Our proposed Housing and Business Choice Plan Change (PC14) from Olive, Greg

Our proposed Housing and Business Choice Plan Change

(PC14)

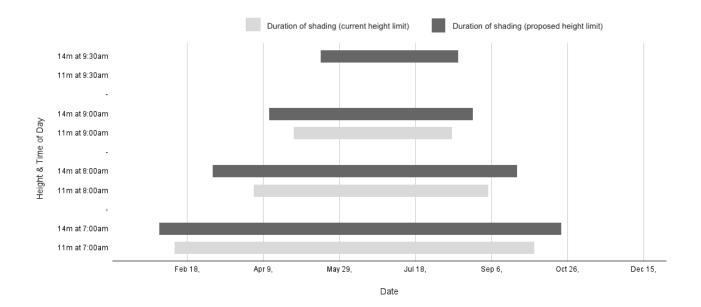
- Cause significant shading at 8am to occur for 200 consecutive days of the year, from 9 March until 24 September. This is an increase of 46 days or 30% longer compared with shading under the current height limit
- Cause significant shading at 9am to occur for 134 consecutive days of the year, an increase of 30 days or 29% longer compared with shading under the current height limit
- This significant shading would continue to occur after 9am and through until at least 9:30am for 90 consecutive days of the year, compared with no significant shading past 9am under the current height limit

See attached chart illustrating the increased duration of significant shading at different times of the morning throughout the year.

Obviously this significant shading impact would be even worse for properties located any closer to a new 4 story development of this nature.

- 1. Change the current Residential Medium Density (RMD) zone at the eastern end of Rugby Street to the new Medium Density Residential (MRZ) zone, rather than the proposed change to the new High Density Residential (HRZ) zone.
- 2. Retain an 11m height limit for this new Medium Density Residential (MRZ) zone, as per the limit in the current RMD zone.

Current Situation
32 House St Veces Brighton

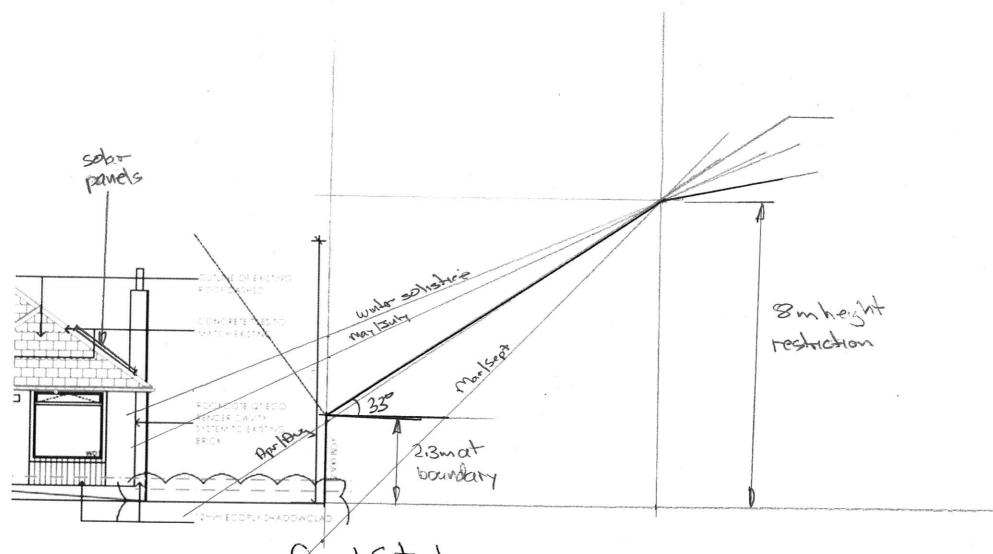
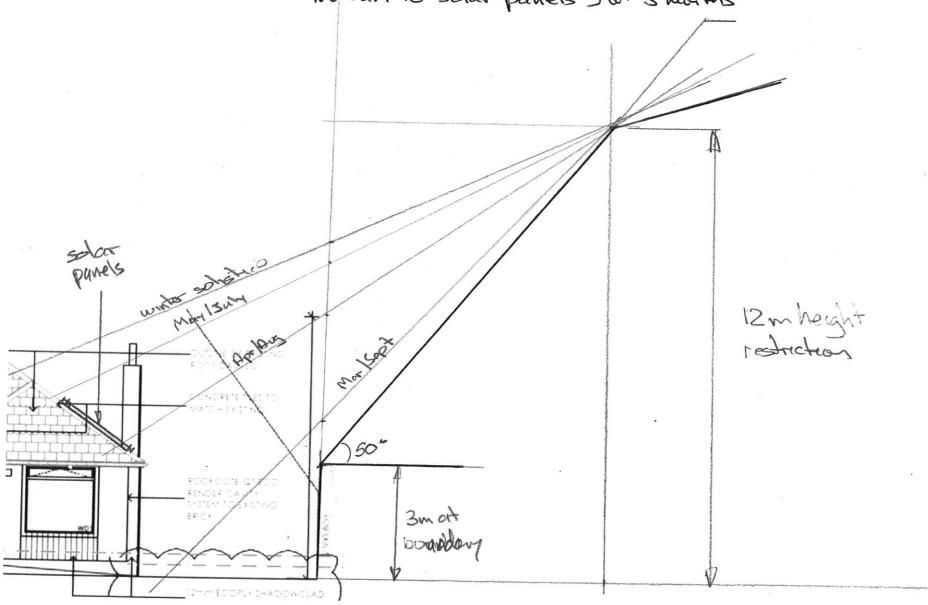
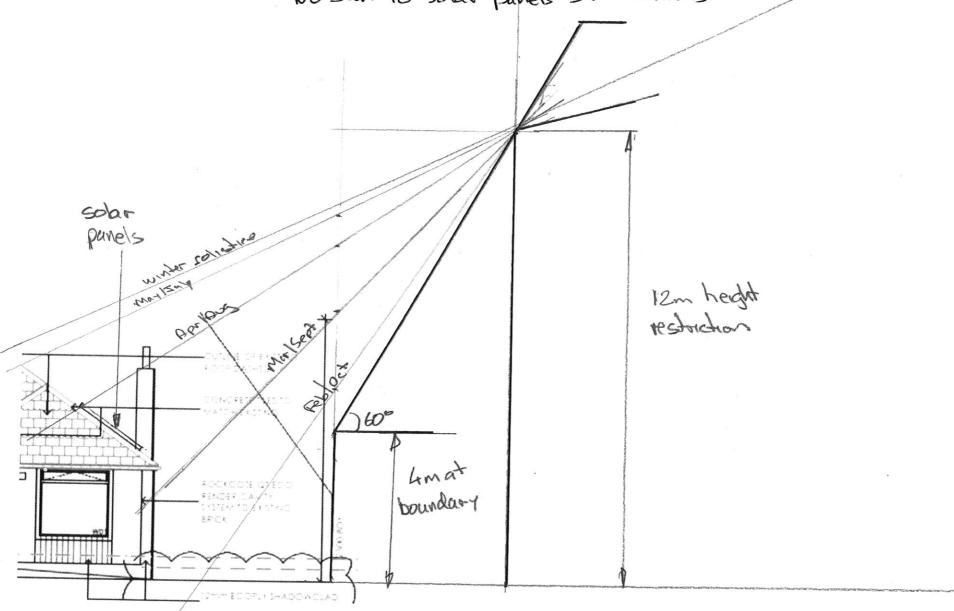
The overriding conclusion from this analysis is that the proposed CCC amendments to the MDRS do not provide for sunlight access at all levels of the building. Furthermore, there is no sun to the solar panels for 3 months. Many people have invested in solar panels and they will not be happy to lose 3 months use, even in winter.

No sun to ground Floor Ior Smonths No sun to solar panels For 3 months

No sun to ground Floor For Smonths, partial sun For 2 months No sun to solar pands For 5 months

Figure 2

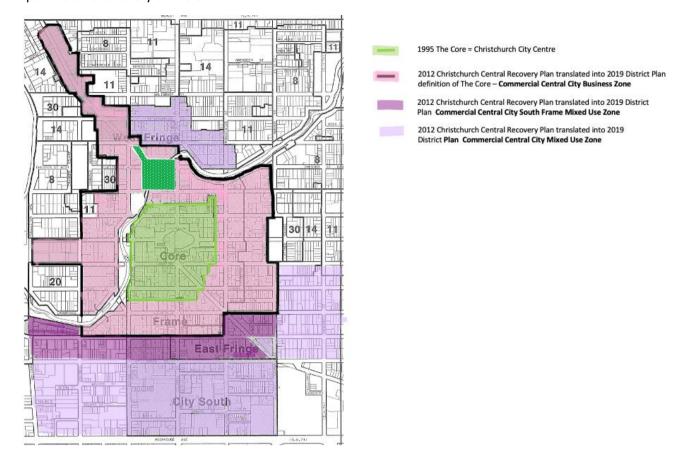
South side of CCZ (dark purple) and MUCC (blue and light purple) has no residential and yet has all the amenity and services (green). The CCZ proposed under PC14 retains the same footprint for the CCZ as used in the CHC District Plan 2019 and continues to include Victoria St.

Figure 7- Busy Main Roads In A Small Area

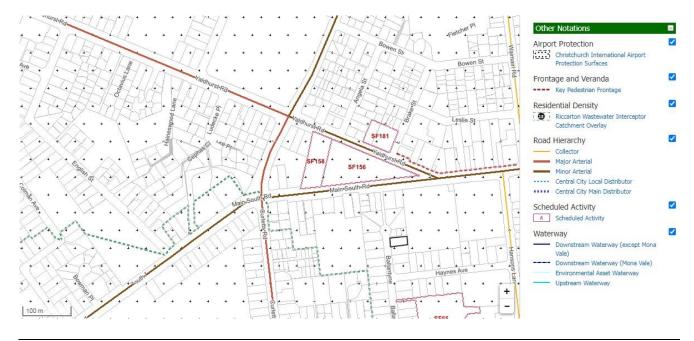
Drainage and water systems are not the only infrastructure topics that intensification will adversely impact. Traffic safety issues and congestion are already a concern, with a Major Arterial Road, Minor Arterial Road, and Collector Road all in close proximity (Fig 7).

For example, Curletts Rd forms part of State Highway 73 and is a busy four-lane road near Our Lady of Victories Catholic Primary School, Middleton Grange School, Riccarton High
